This is to certify that IRISH HERITAGE CENTER Consignee Construction  
has permission to repair to bell tower floors resulting from fall collapse  
AT 3 GRAY ST

Permit Number: 071426

MAINE IRISH HERITAGE CENTER  
BELL TOWER RESTORATION

Meeting Date: 18 December 2007  
 Project: Irish Heritage Center  
 Attendees: Captain Greg Cass (GC) – City of Portland  
 Matt Tonello (MT) – Consigli Construction, Inc.  
 Janice Narowski (JN) – Consigli Constuction., Inc.  
 John Turk (JT) – ttl-architects, LLC  
 Copies to: Jeanie Bourke, GC, MT, JN  
 Submitted by: John Turk

**SK-4**

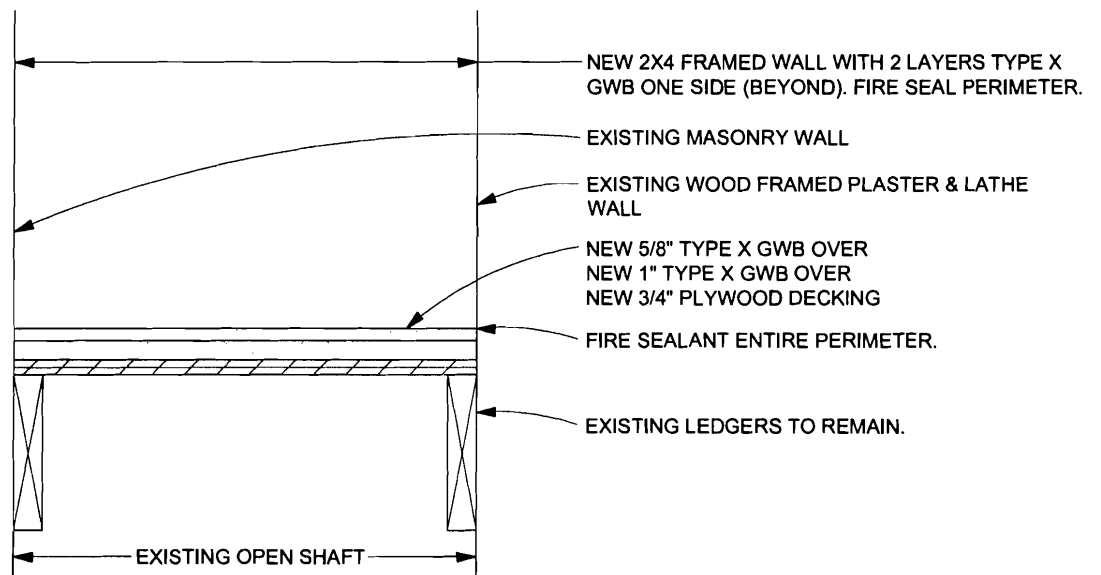
1.1.3	GC suggested that the exhaust duct and plumbing vents that exhaust into the Vestibule be fire rated. This would entail extending them to the open Belfry Level, wrapping them in 1 hr. rated shaftwall and adding a fire damper between the Basement Level and the Primary Sanctuary Level.

SK-3

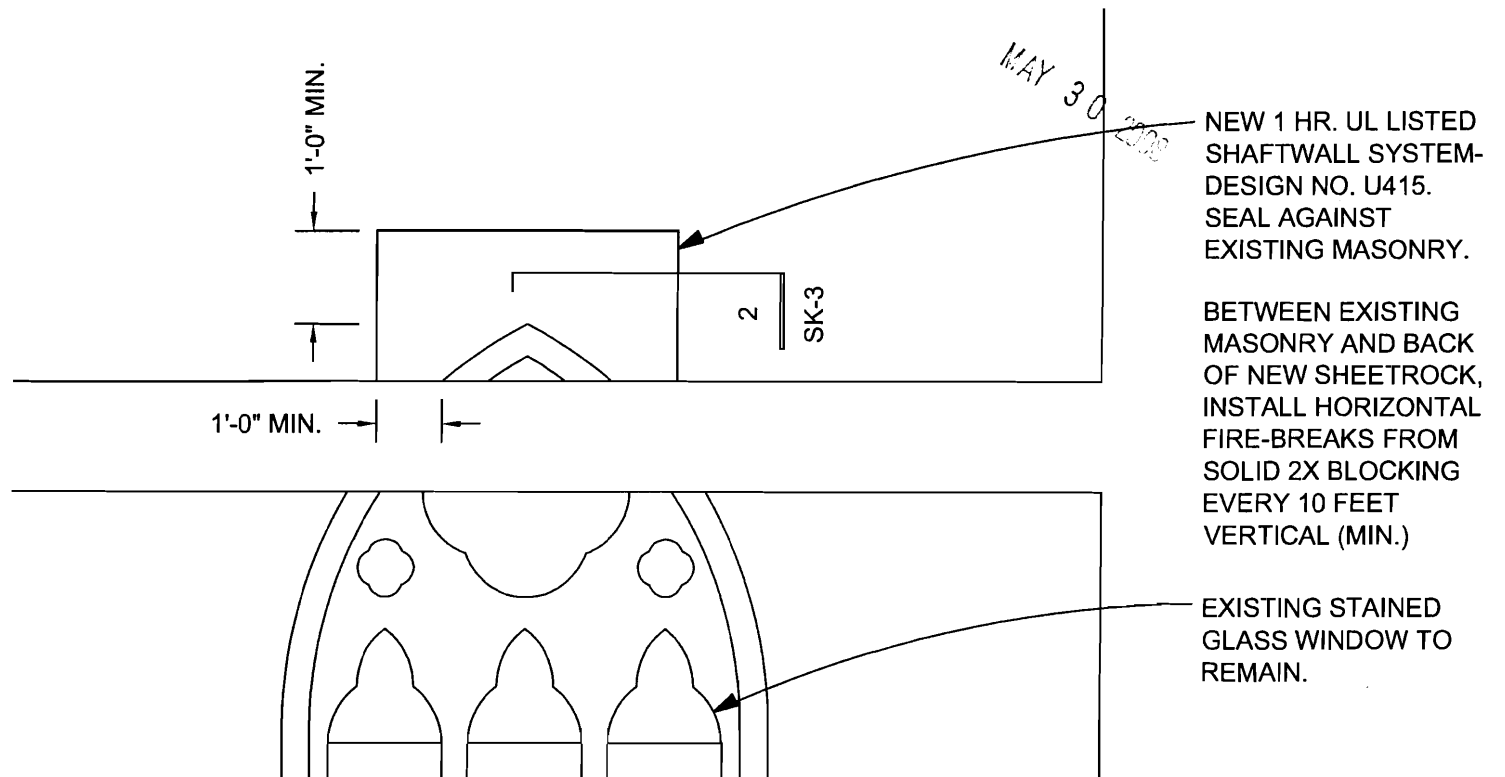
Instead of wasting time drawing a detail at the void in the wall at the Bride's Room, please direct your crew to install two layers of sheetrock at the floor surface and fill perimeter voids with fire sealant.

The void between the masonry and the back of the plaster lathe needs to be filled with mortar. This treatment is to occur from the floor level all the way to the top of the arch.
